Review of Long-Term Maintenance Plans for the South Jetty, Grays Harbor, Washington

by *Special Subcommittee of the Committee on Tidal Hydraulics and
Coastal Engineering Research Board*

Final report

Prepared for U.S. Army Engineer District, Seattle
Seattle, WA 98124-2255

Figure 15. Beach revetment alternative

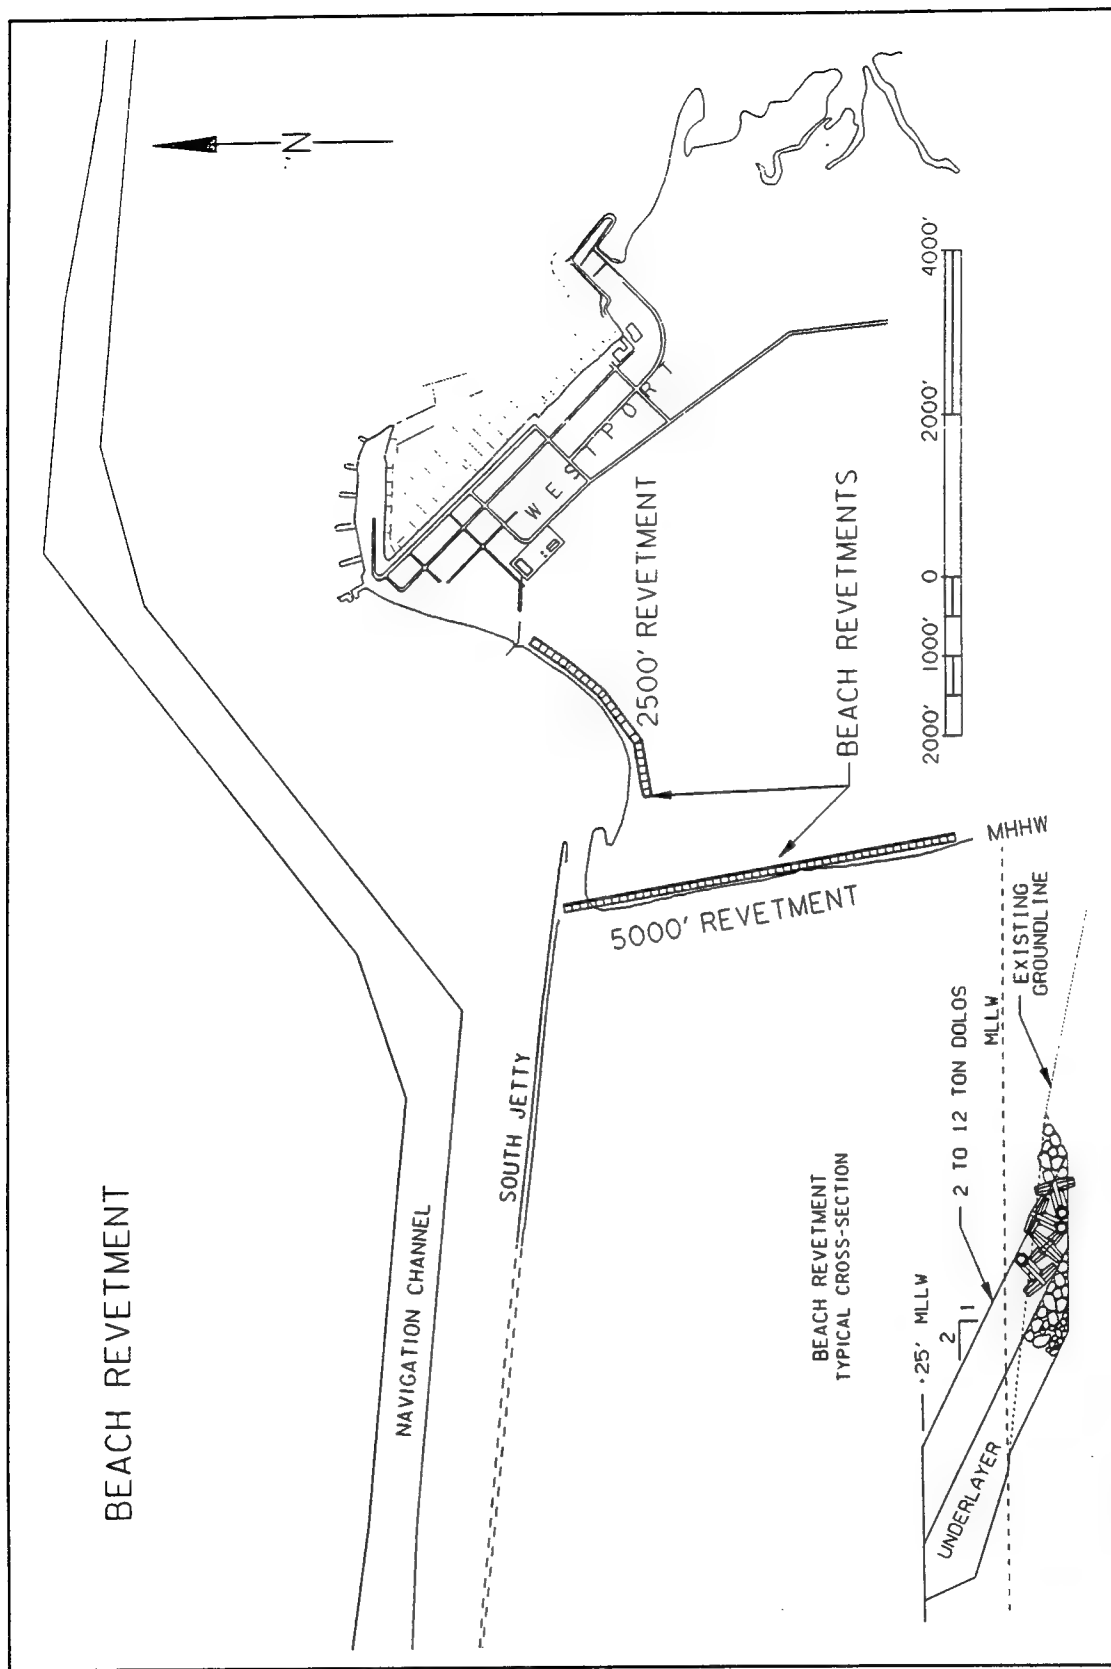
46. This alternative is shown in Figure 15. It includes revetment along South Beach and extension of the revetment in Half Moon Bay. In addition to a very high initial cost, erosion of sand at the base of the revetment down South Beach would cause continuing requirements for expensive maintenance.

Figure 16. South jetty extension and revetment alternative

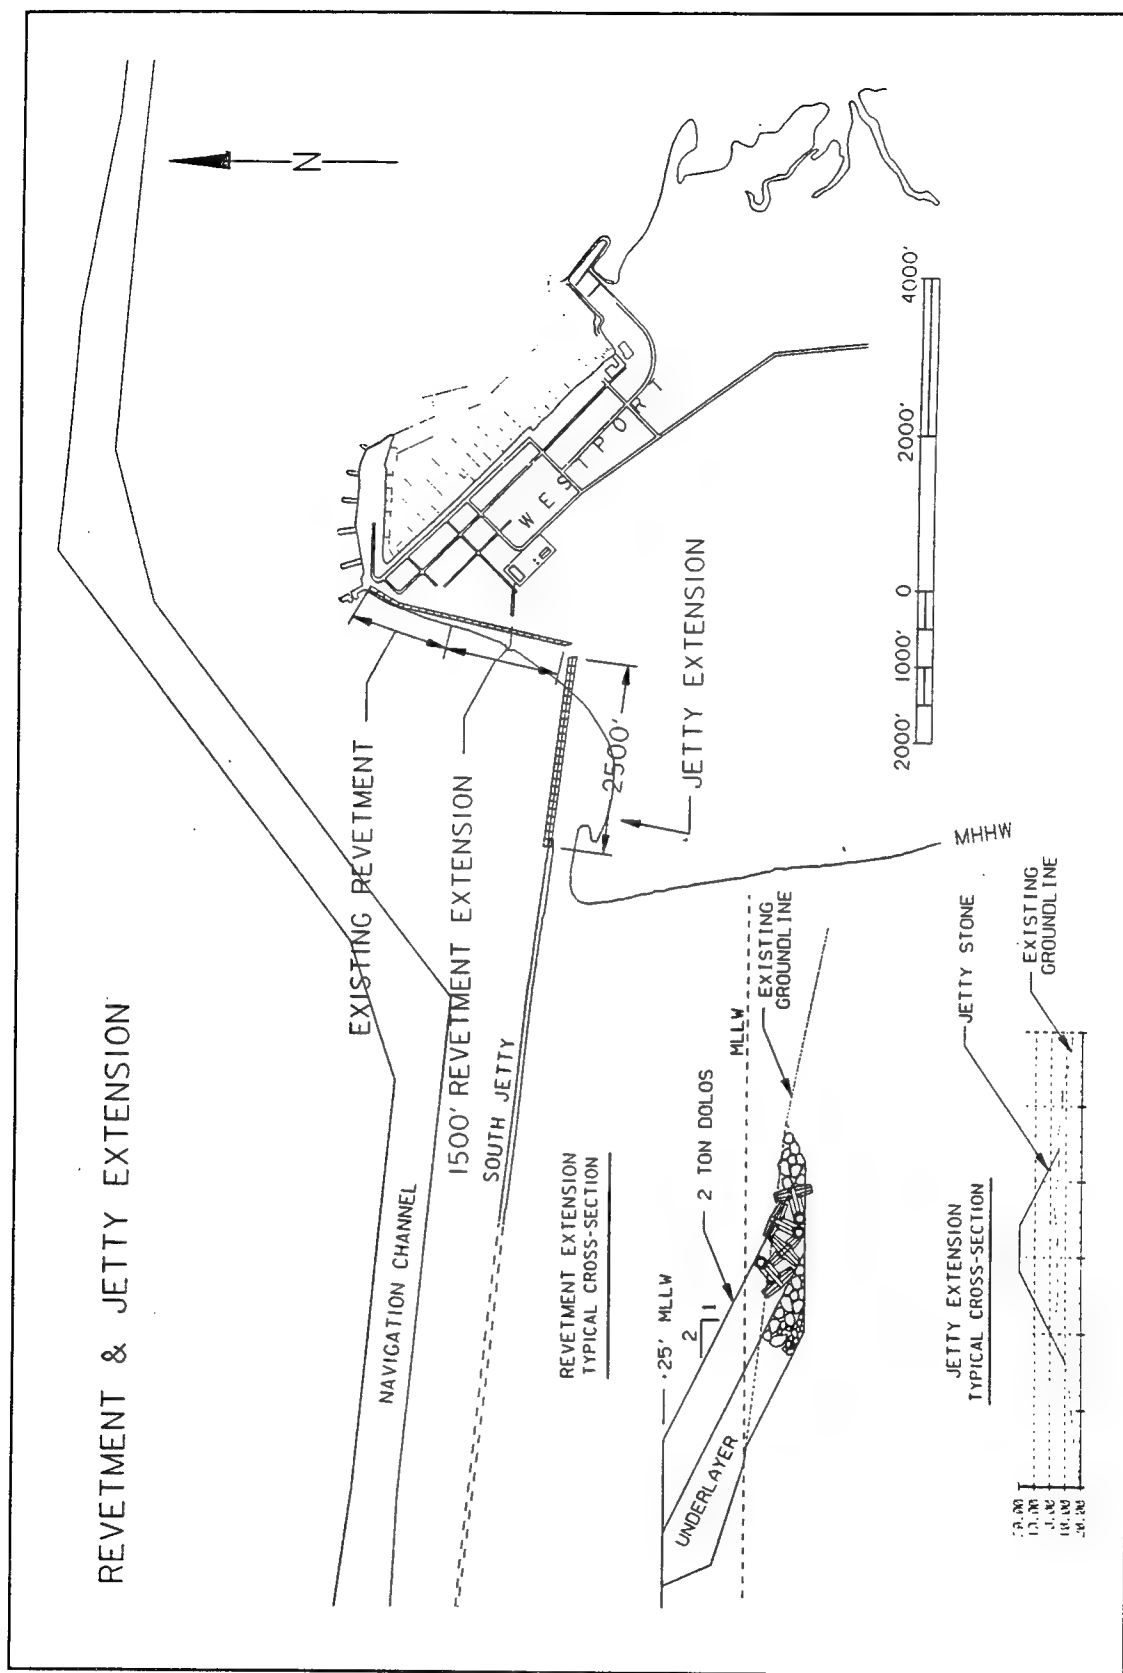
47. This alternative is shown in Figure 16. It includes a 2500-ft eastward extension of the jetty to the junction of a 1500-ft southward extension of the Westport revetment. Protection against erosion in the Half Moon Bay area and of Point Chehalis against waves and currents in the entrance would be provided. This plan would also provide assurance that the entrance channel would not be captured by South Beach erosion in the breach area. Curvature of the jetty near its junction with the revetment extension to provide a smooth alignment along the channel bend would reduce construction and maintenance costs. No means of reducing erosion of South Beach is shown.

Figure 17. Spur groin alternative

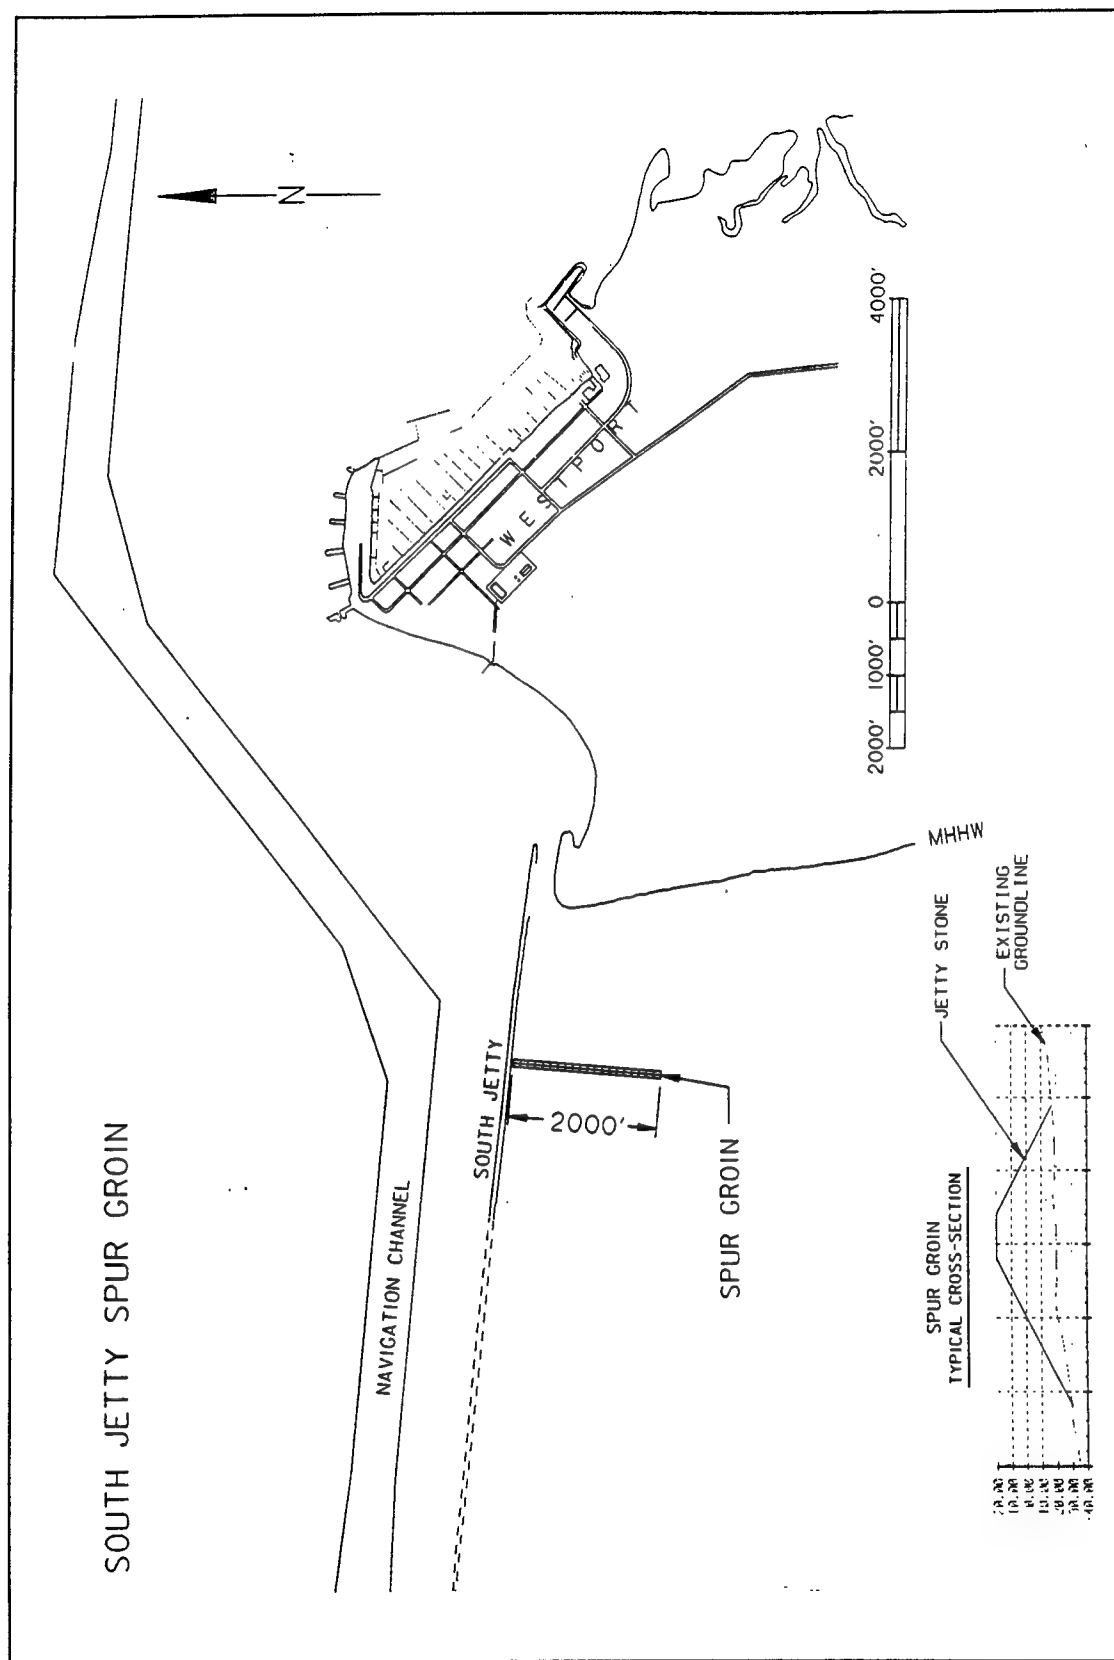
48. This alternative is presented in Figure 17. It includes a 2000 ft groin perpendicular to and on the south side of the South Jetty located about 2000 ft from its east end. No direct closure of the breach is indicated; however, the intent of the groin is to interrupt the seaward current along the jetty and to facilitate accumulation of sand in the breach area and out along the south jetty. This alternative could provide long term protection of the jetty but would require expensive maintenance. It would not diminish erosion in Half Moon Bay. Its efficacy depends on a supply of sand from the south, possibly augmented by placement of dredged material. Design of such a groin should include computations of northward littoral transport and possibly a physical model study to determine optimum location and length of the groin.

Figure 18. South jetty reinforcement alternative

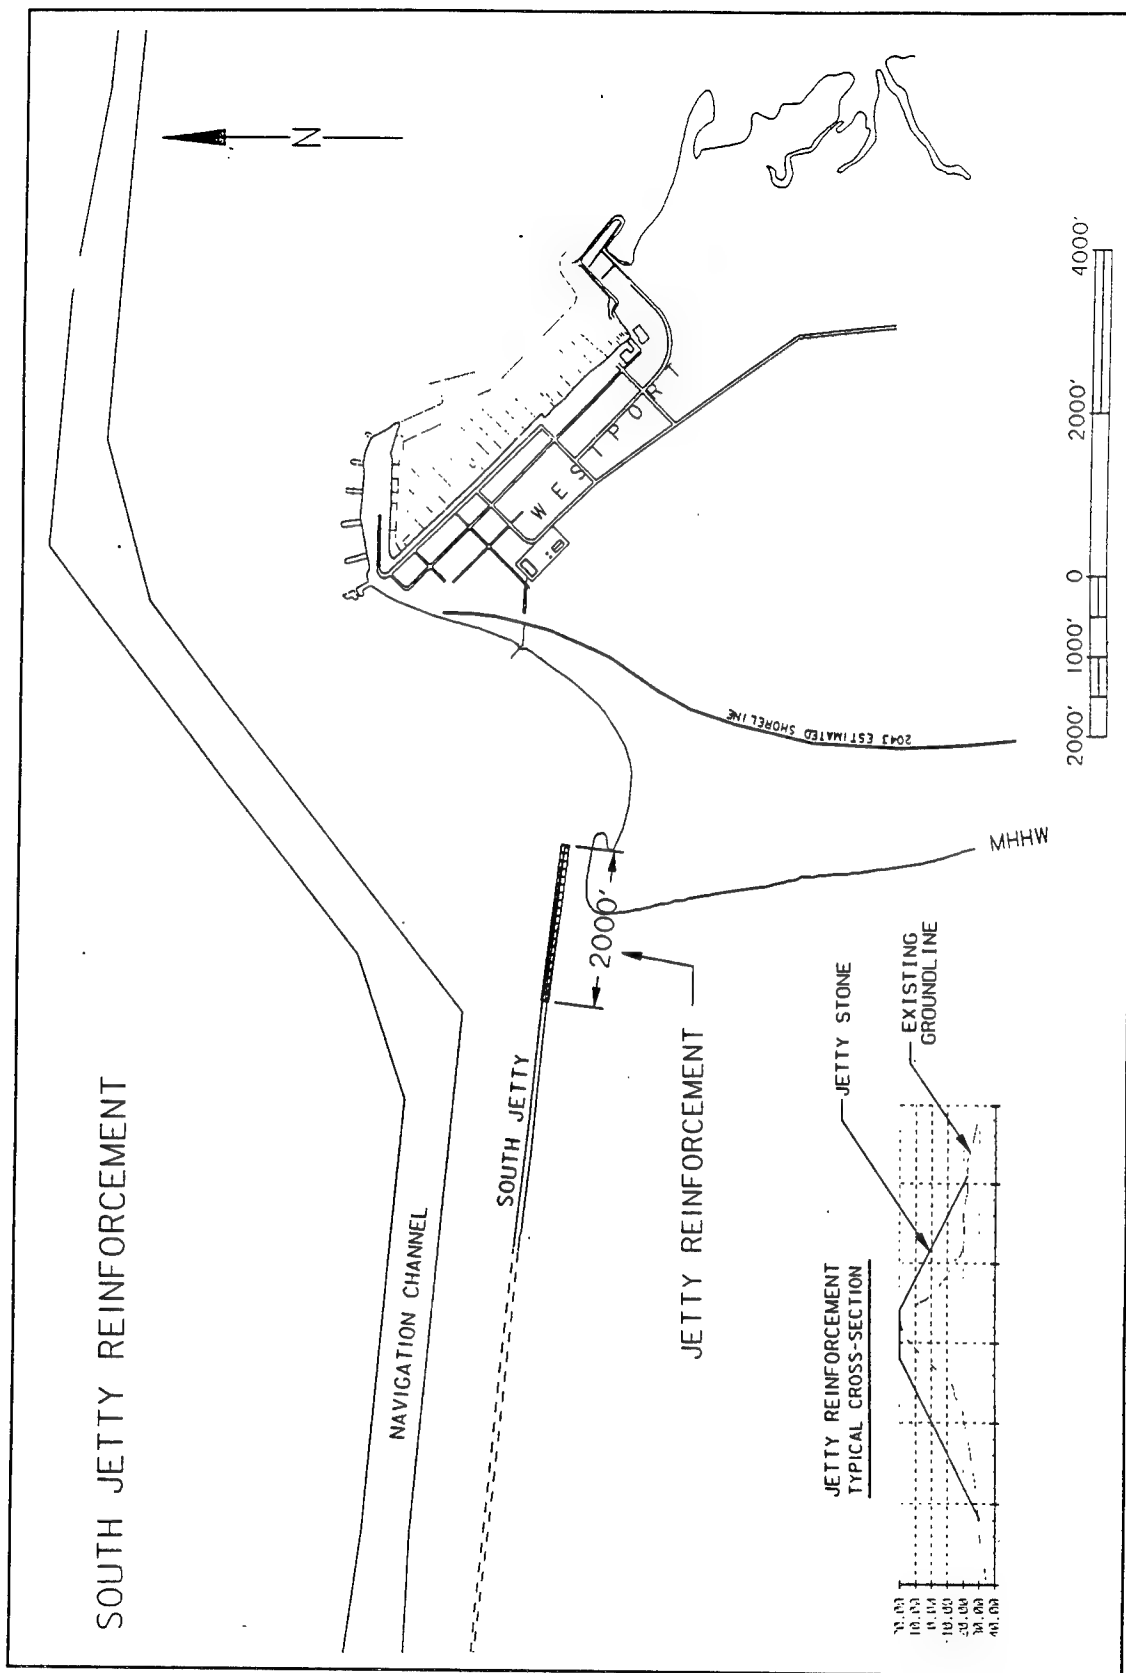
49. This alternative is presented in Figure 18. It includes reinforcement of 2000 ft of the east end of the south jetty. It would maintain stability of the structure in the presence of continuing erosion of South Beach and Half Moon Bay. Continuous monitoring of the beach would be required, and risk of capture of the navigation channel by erosion of the breach would persist.

Figure 19. Nearshore berm alternative

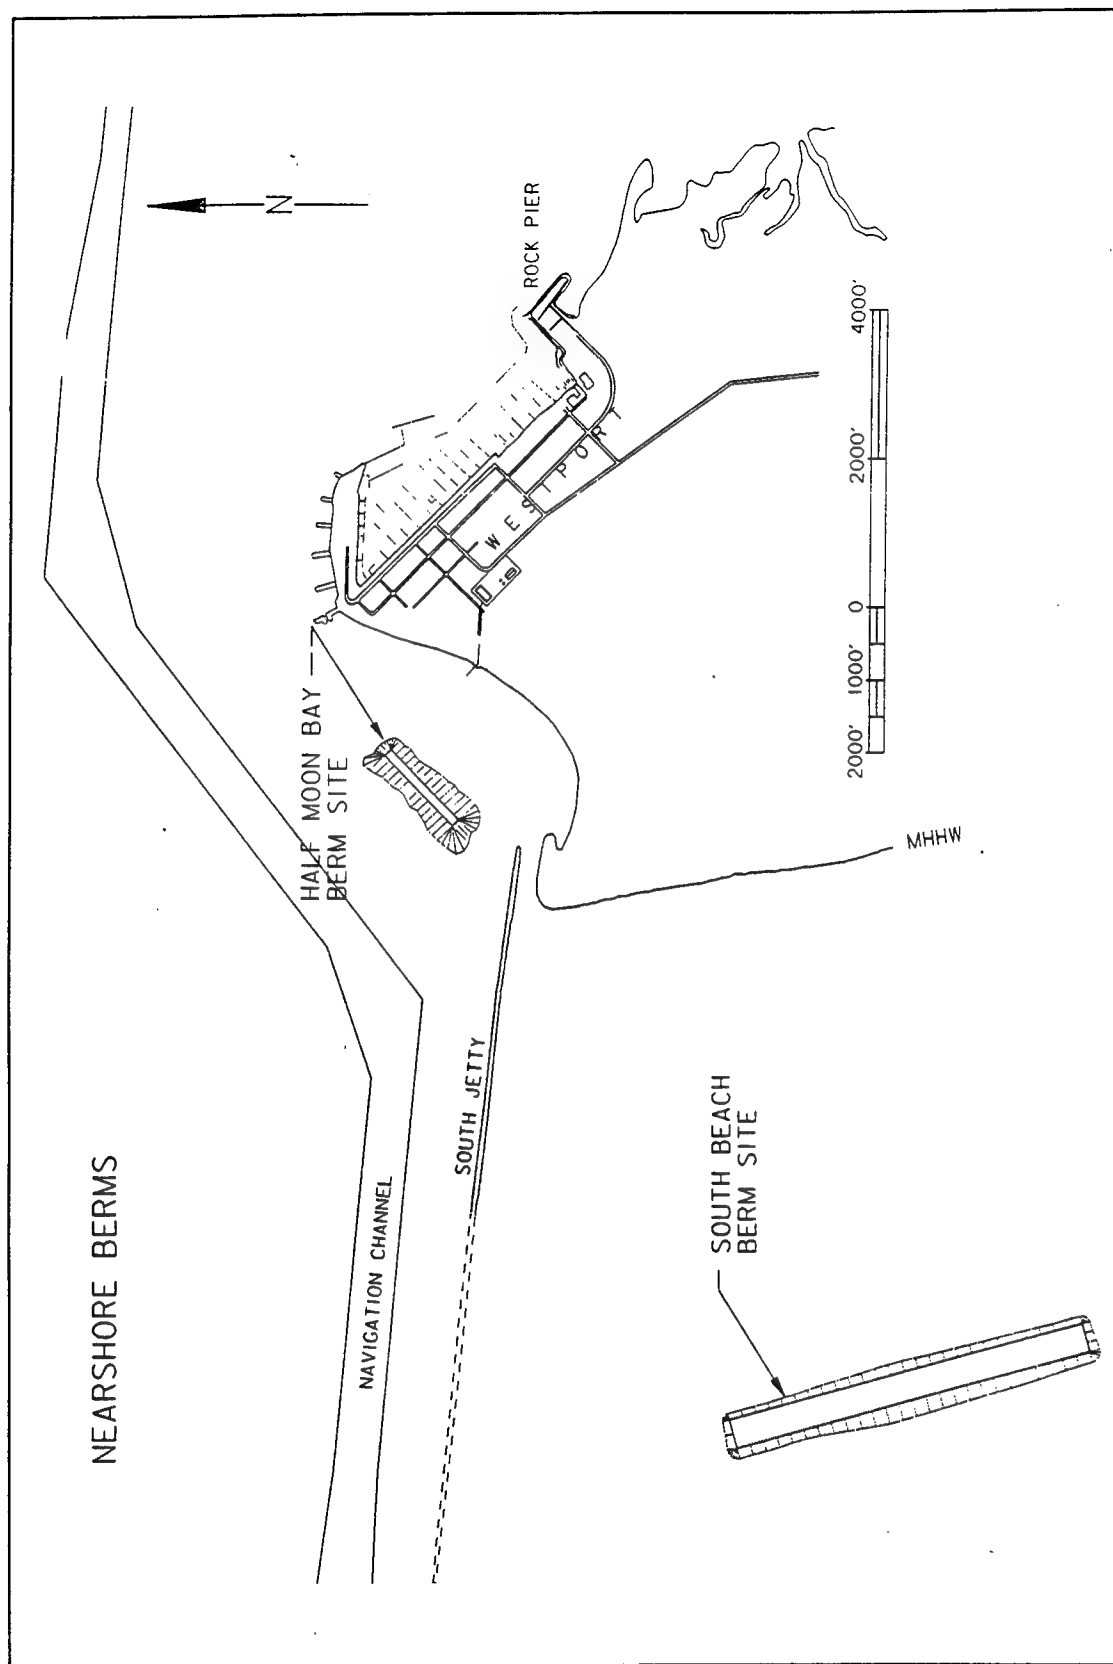
50. Annually resupplied nearshore berms shown in Figure 19 would be placed in Half Moon Bay and near the north end of South Beach. The purposes of these berms would be to reduce wave action and supply sand to the beaches. Up to 500,000 cubic yards a year of sandy dredged material could be placed between the -20 and -40 ft contours near South Beach. The berm would cover an area 5000 ft long by 500 ft wide. An initial berm 2000 ft long containing 385,000 cy of sand was placed at the 40-ft contour during September and August, 1993, and an additional deposit is planned at the 30-ft contour in September, 1994. An initial 185,000 cy berm was placed in Half Moon Bay in 1992 and an additional 200,000 cy was added in May, 1994. Placement of these berms costs little above the cost of the previous disposal operations, and the practice should be continued to retard shoreline erosion.
